**SAN ANTONIO WATER SYSTEM
C-5 CULEBRA – CASTROVILLE TO LAREDO AND C-28 ZARZAMORA CREEK SAN
GABRIEL TO NW 23RD STREET, PHASE 1A
SAWS JOB NO. 14-4507
LAREDO STREET TO LOMA VISTA TO CHIHUAHUA PROJECT
SAWS JOB NO.14-4007**

ADDENDUM NO. 3

October 21, 2014

Consulting Engineer: CP&Y, Inc., TBEF Registration, #F-1741

SAWS JOB NO. 14-4007

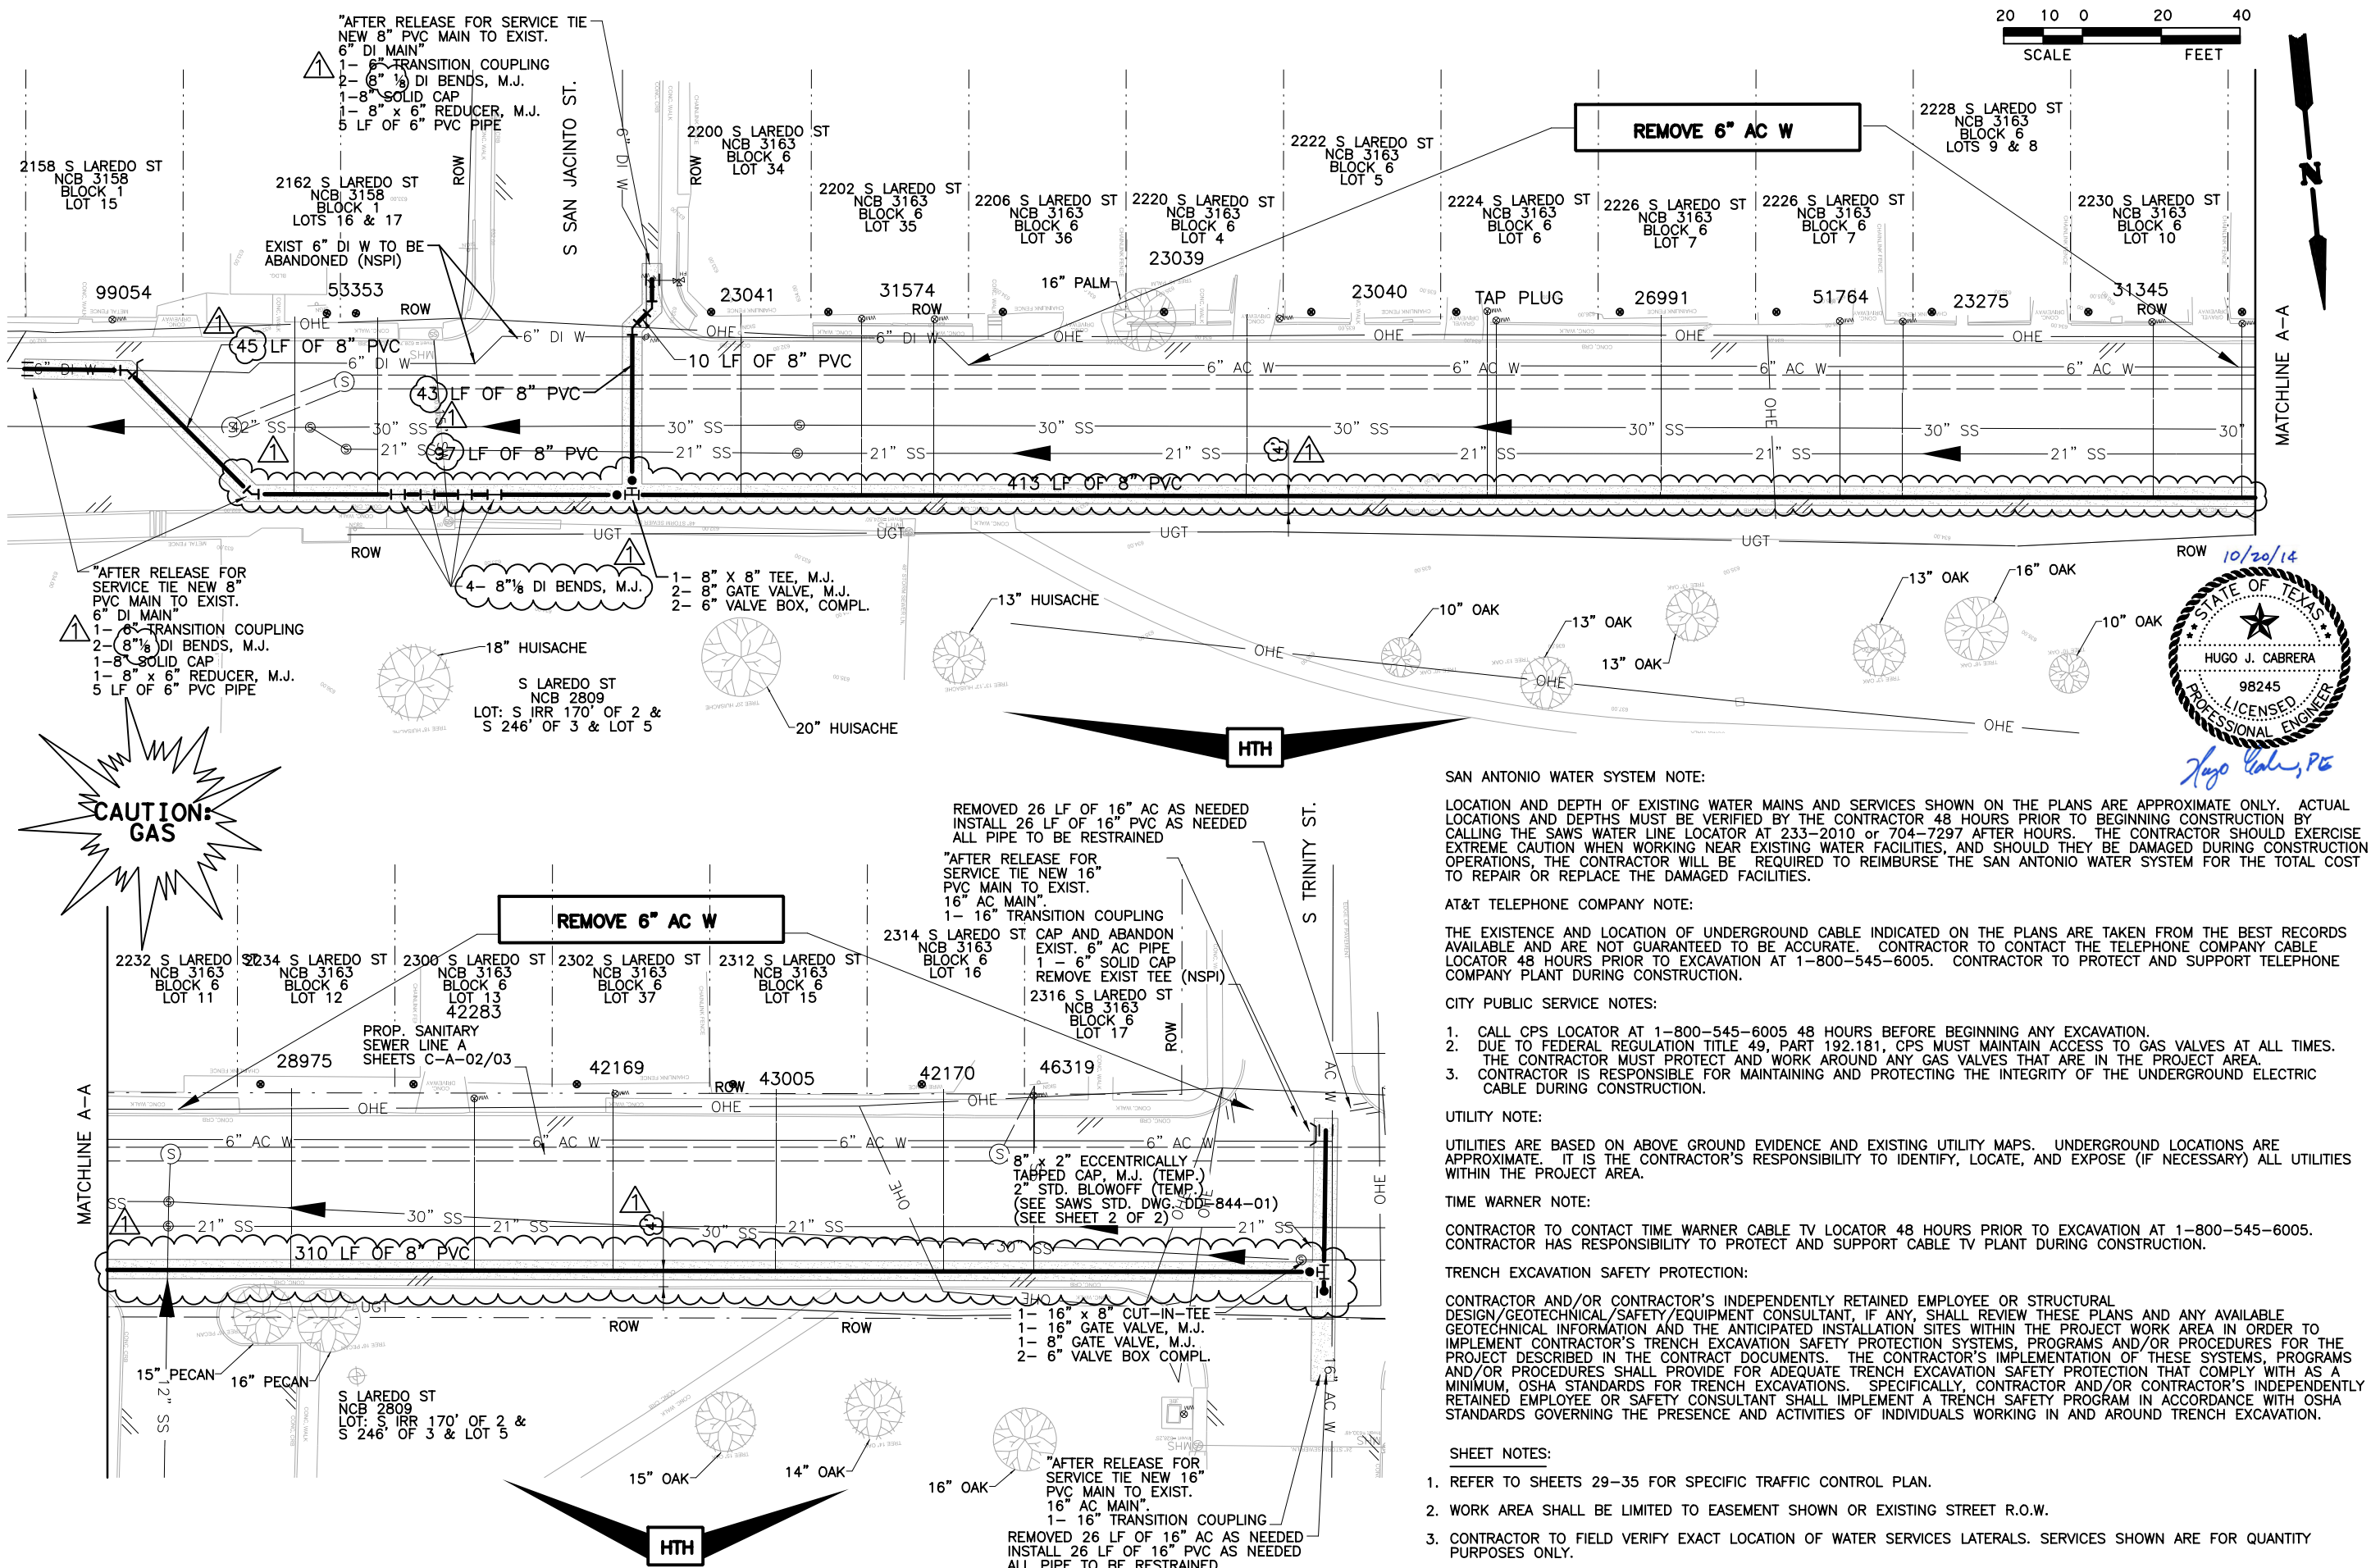
- E. Delete Sheet C-BP-02, Sheet 24 of 45, in its entirety.
- F. Delete Sheet C-WTR-01, Sheet 25 of 45, and replace with attached sheet C-WTR-01.

- **Plan sheet 25 of 45 shows an existing storm sewer at approx. STA 10+25, will the water line need to be installed above or below the existing storm sewer?**

A: The waterline will need to be adjusted underneath the 15-in existing storm sewer. The plans will be revised to reflect the change in design.
